Dolby Laboratories Inc

Field Bulletin 223

Models CP500 and DA20

Slow switching to Dolby Digital sound

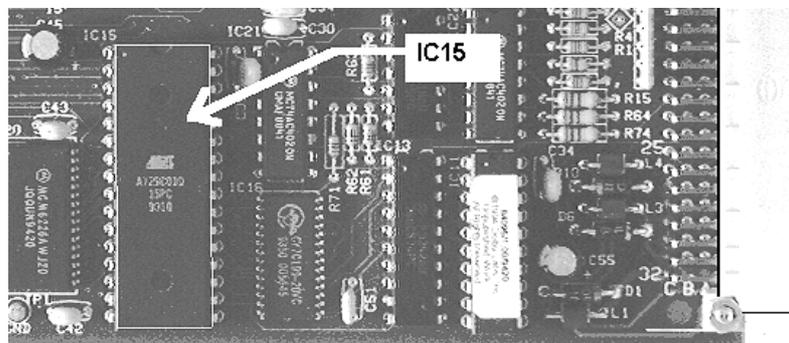
1. Rotate the switch on the Cat. No.673(A) to position **8** and press the reset button at the bottom of the card. After a few seconds, the letter "A" should appear on the seven segment red LED display.
2. Start the upgrade program either by powering up the computer with the floppy disk in place or by running the program from DOS by typing **upgrade** at the DOS prompt.
3. After the program has opened, press function key **F8** on the computer to load the new file. As the new software module is loaded, the display on the Cat. No. 673(A) will change from **A** to **C** and then back to **A**.
4. After the file has been loaded press function key **F4** to exit the program.
5. Return the rotary switch on the Cat. No. 673(A) to position **0** and press the reset button at the bottom of the card.

To check that the module has been upgraded successfully, turn the rotary switch at the top of the Cat. No. 673(A) card to position **1**. The LED display should now show the letter "A".
